Cedar Creek WWTP Improvements

Project No. 24022

ADDENDUM NO. 3 TO THE CONTRACT DOCUMENTS

JOB NO: 24022
SHEET NO: 100M301

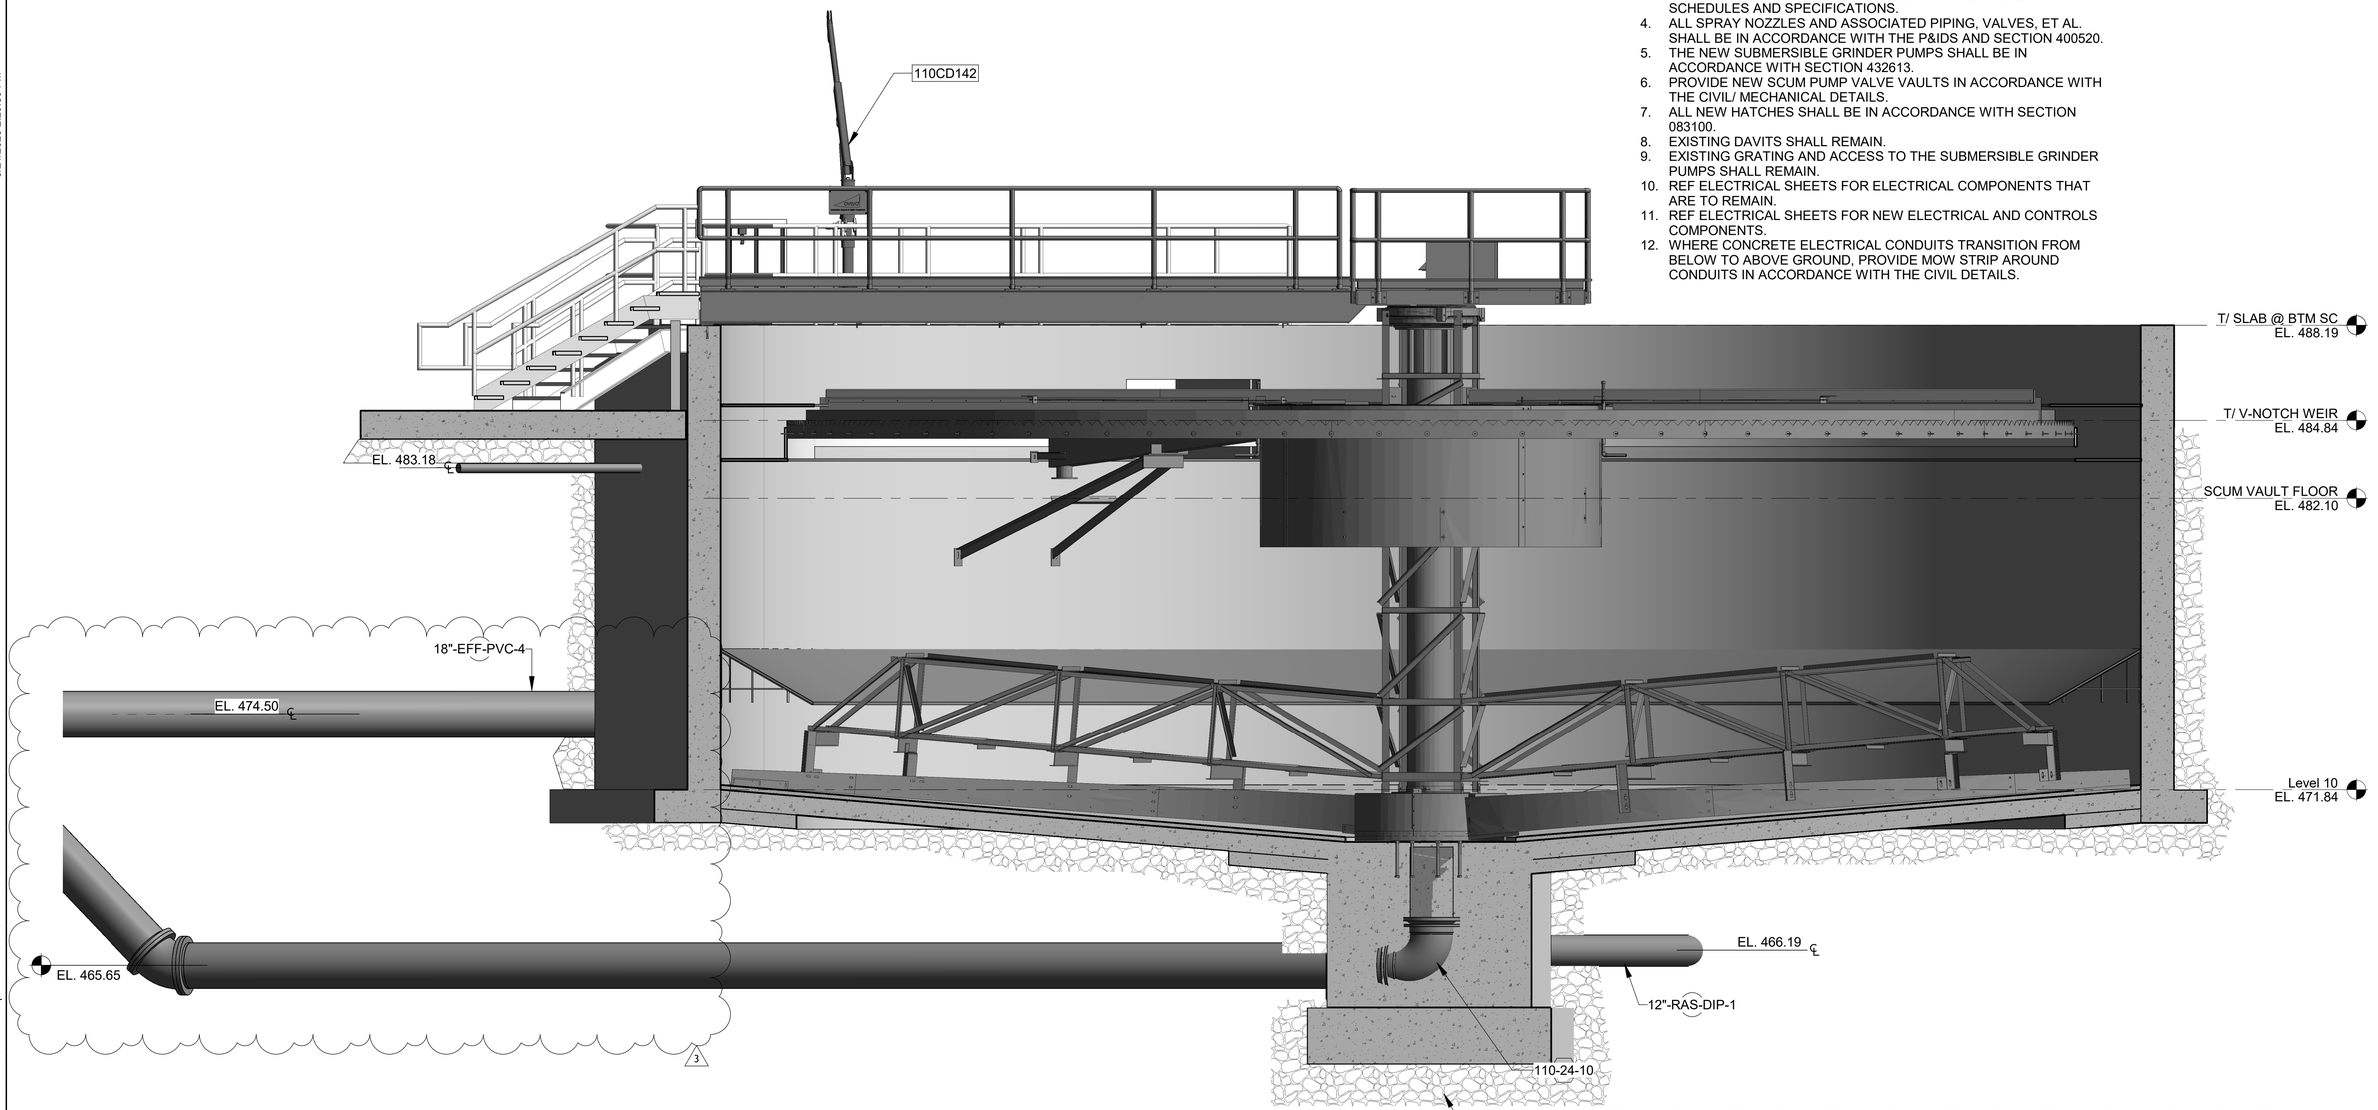
42	The elevations and fittings shown on line 24”-MLSS-DIP-4 on drawing sheet 05C311 do not appear to match what’s shown on 100M301 and 110M301. Please confirm that the elevations and fittings shown on 100M301, 110M301, etc. on mechanical drawings are correct.	See Addendum No. 3.	Addendum 03
43	Drawing sheet 05C331 (24”-MLSS-DIP-4) includes 3ea anchor collars. Drawing sheet 05C332 (24”-MLSS-DIP-5) does not list or show anchor collars but is a similar line. Are anchor collars required on 24”-MLSS-DIP-5?	Detaill 00-SZ-07 only apply to connections to existing structures.	-
44	See sheets 100M101 and 05C333. Please confirm that a pipe connects the effluent box of existing Clarifier 1102 to the effluent box of existing Clarifier 1101. The presence of an existing pipe is the only conduit I can find for Clarifier 1102’s effluent to reach the Tertiary Filters.	Confirmed, see 00G004 and Section 014000, page 10, 1.20.	-

REV. NO.	DATE	DRWN	CHKD	REMARKS
3	5/22/26	MAB	BNW	REVISED TO MATCH CIVIL PIPING 05C311
